**TO:** Salvatore Ervolina, Assistant Director, Division of Environmental Remediation  
**FROM:** Edward R. Belmore, Director, Remedial Bureau D *Edward R. Belmore*  
**RE:** Record of Decision - Luzerne Road Site, Warren County, Site No. 557010  
**DATE:** MAR 29 2005

Name of Site and No.: Luzerne Road Site, No. 5-57-010

# **APPENDIX A**

**Figure 11** High-temperature Thermal Mass and Energy Balance  
Luzerne Road Site

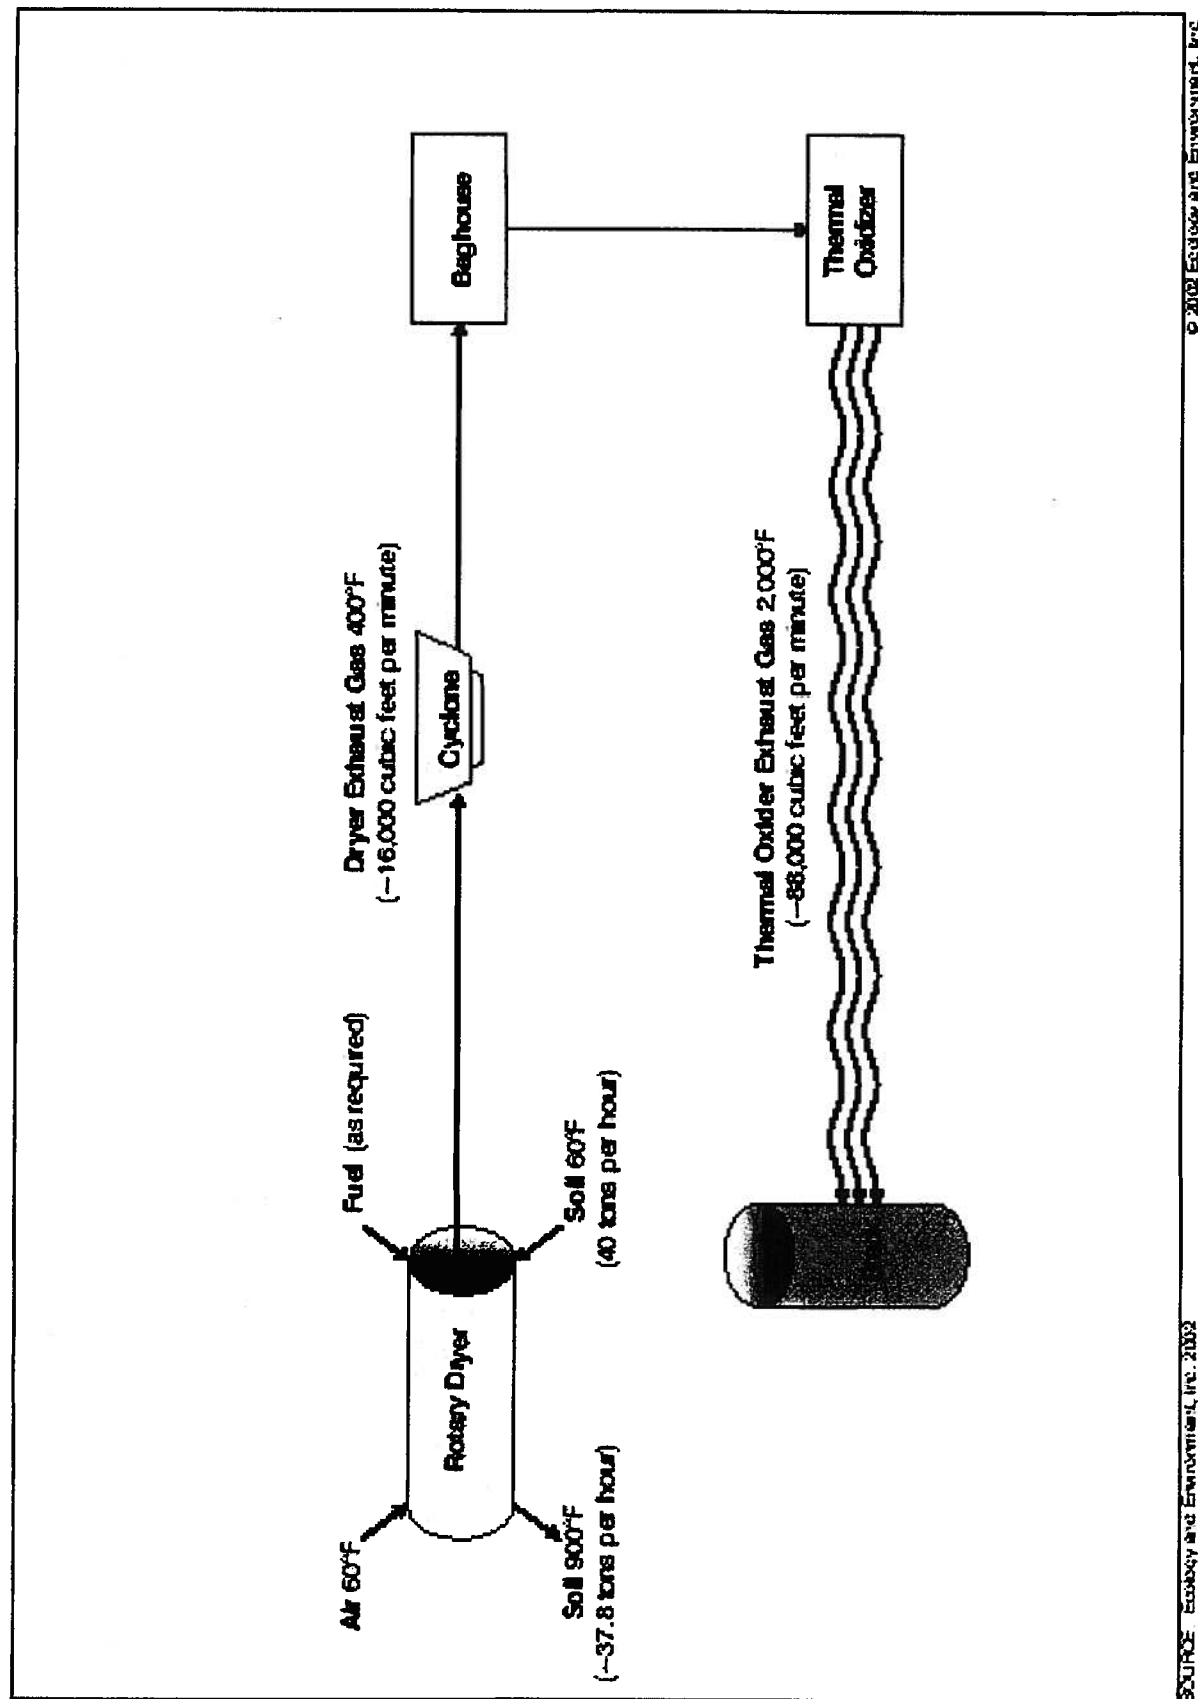
remediation effort. General discussion of the equipment arrangement and Figure 11 of the PRAP depict what is commonly known as a "cold plant" configuration which means the process air stream and volatilized contaminants are cooled to enter the baghouse particulate removal equipment prior to entering the thermal oxidizer for destruction. The potential problem with this is the baghouse can only handle up to approximately 400° F and the volatilized contaminants (in this case PCB's or other SVOC's) will condense and collect on the fines and be filtered out at the baghouse without being destroyed.

Alternatively in a "hot plant" configuration the thermal oxidizer receives the gas stream containing volatilized contaminants immediately after desorption, and then elevates the gas stream temperature to destroy them prior to any cooling for introduction to the baghouse or other plant component.

In summary, the hot plant volatilizes the contaminants, oxidizes them and then filters out particulate from a cooled gas stream.

RESPONSE: The NYSDEC did not intend to specifically call for a “hot plant” or “cold plant” process. Figure 11 was used as an example to describe the thermal desorption process. The specific process for thermal desorption of the PCB contaminated soils at the Luzerne Road Site will be determined during the remedial design.

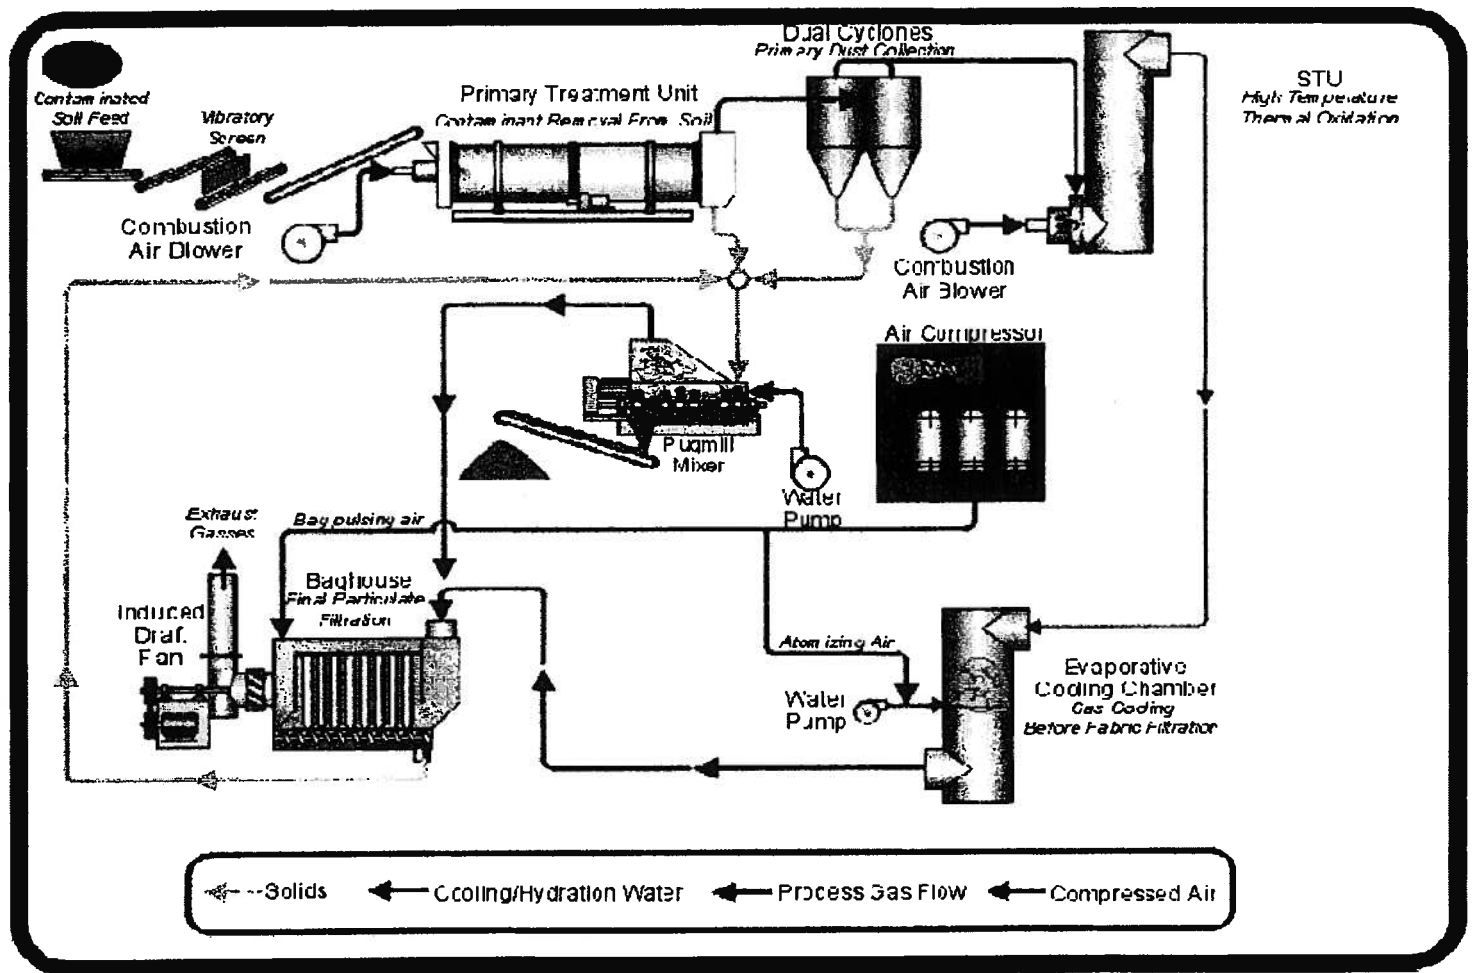
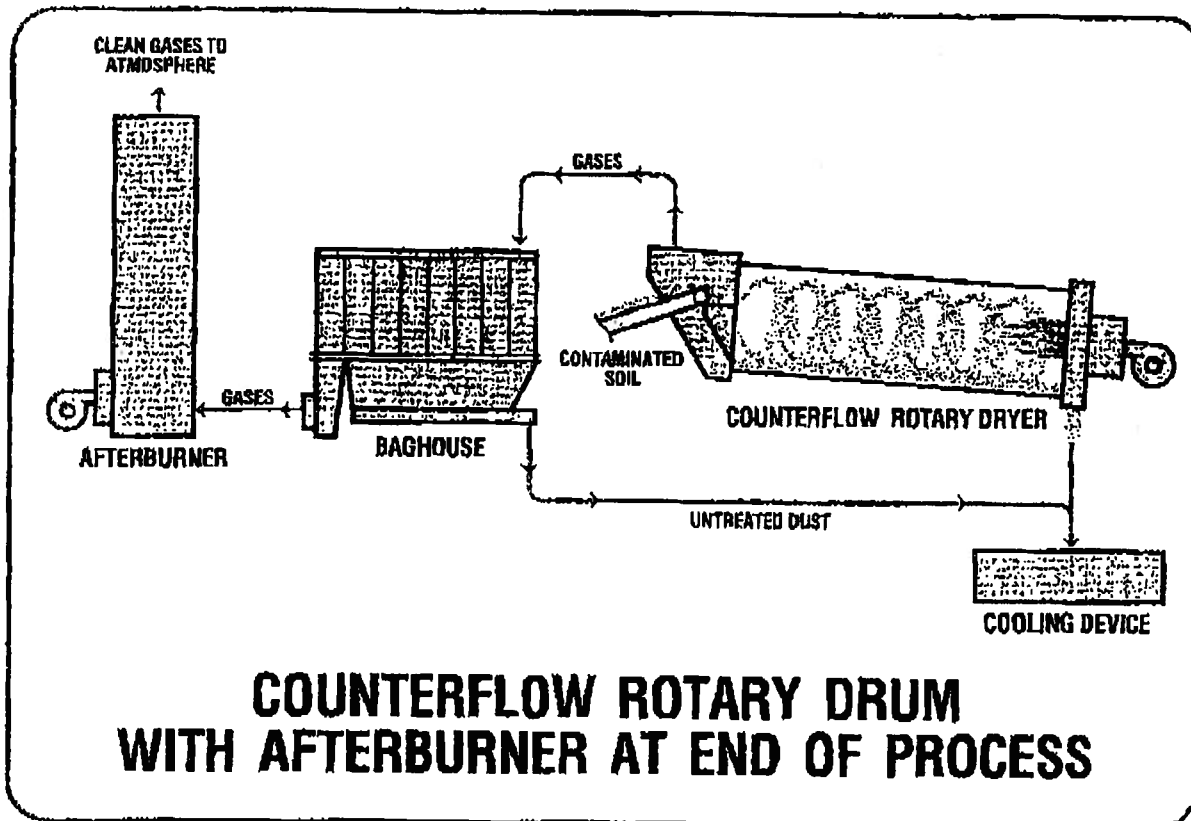
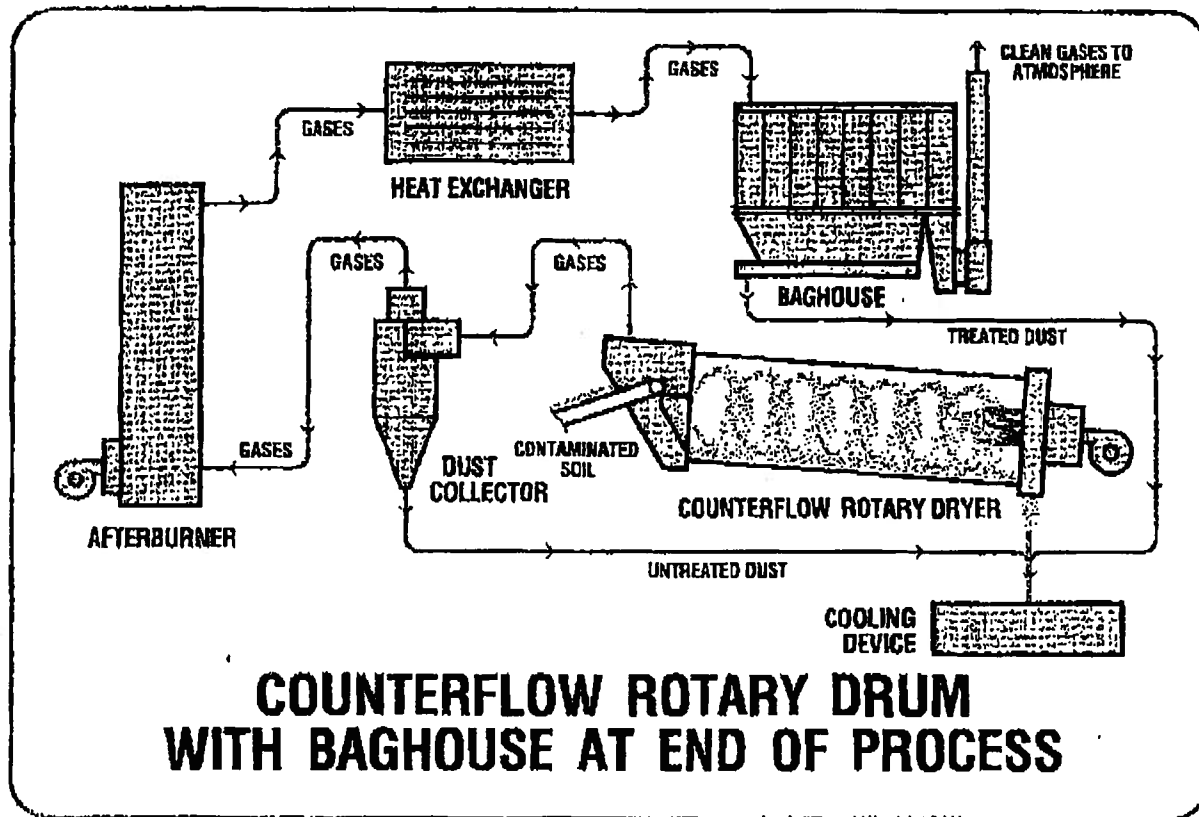
A schematic of a "hot plant" configuration and a plant comparison by *Soil Purification Inc.* are included for your review.
